AMENDMENT R0002

SUBJECT: Amendment Number 0002 to Request for Proposal (RFP) No. W912DW-04-T-2102, entitled "Shoot House, Fort Lewis, WA"

**RANGE 25 TWO-STORY SHOOT HOUSE,
 FORT LEWIS, WASHINGTON
 Project Number 57653
 File No. 22s/171-22-01**

FOUNDATION PLAN

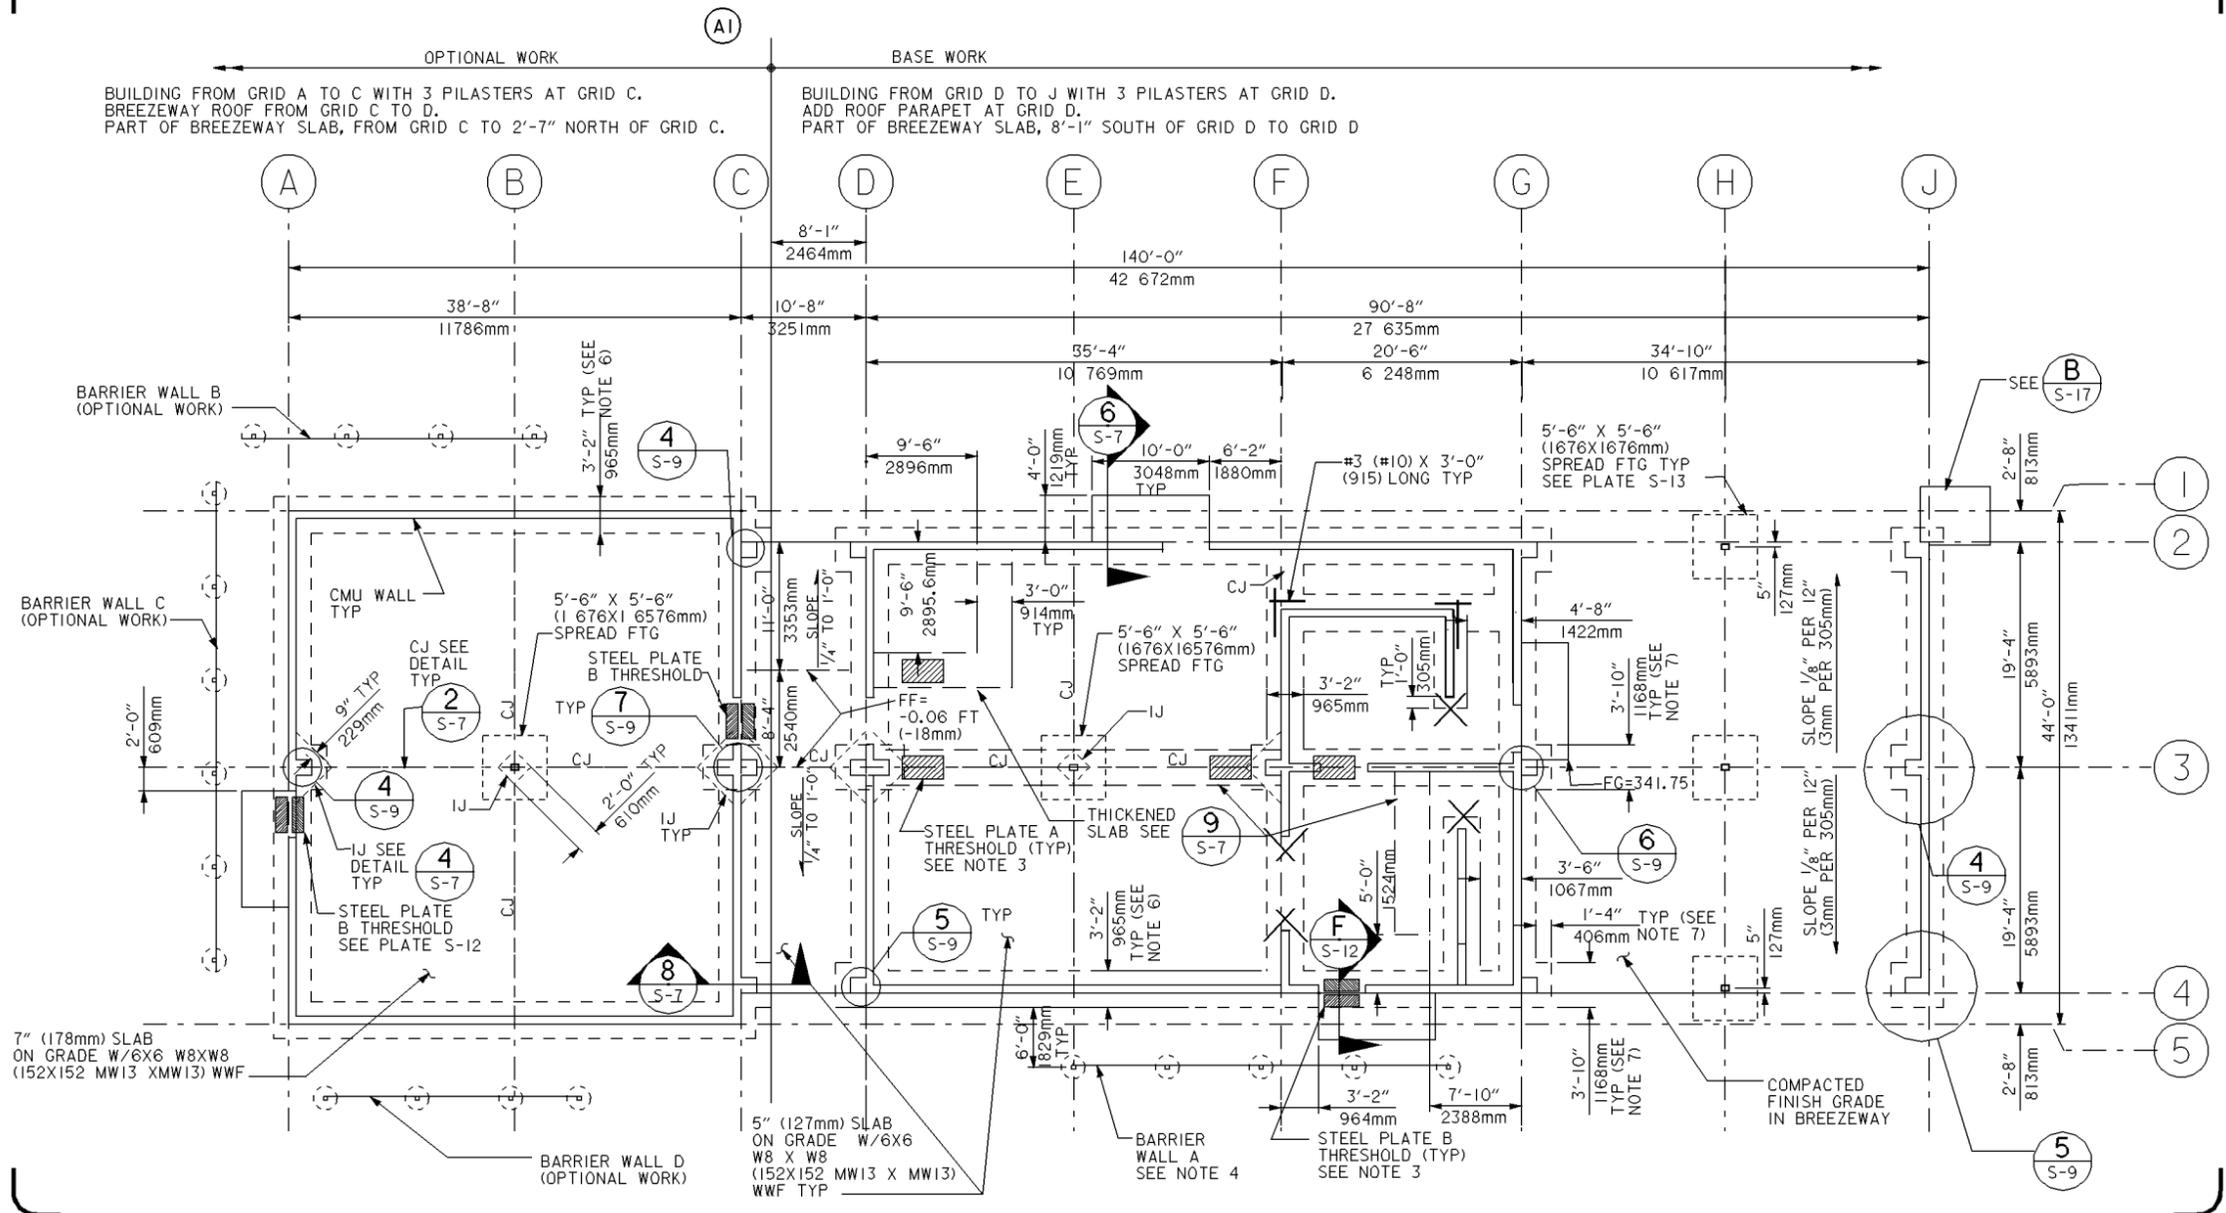
Plate S-3:

- a. Add callout 1/S-7 to 7" slab and 5" slab notes.
- b. Note 6, add "see section 7/S-3."

The Building from Gridline D to Gridline J with the 3 pilasters at Grid D shall be base work. Add a roof parapet at Gridline D. Parapet shall be the same as those on Gridlines 1 and 5 between Gridlines D – F. Part of the breezeway slab on grade, (from 8'-1" south of Gridline D to Gridline D) will also be in the contract. (Please see Plate S-3, Revision 0002)

The Building from Gridline A to Gridline C with 3 pilasters at Gridline C, the roof between Gridline C and D, part of the breezeway slab on grade (from Gridline C to 2'-7" north of Gridlines C) shall be optional work. (Please see Plate S-3, Revision 0002)
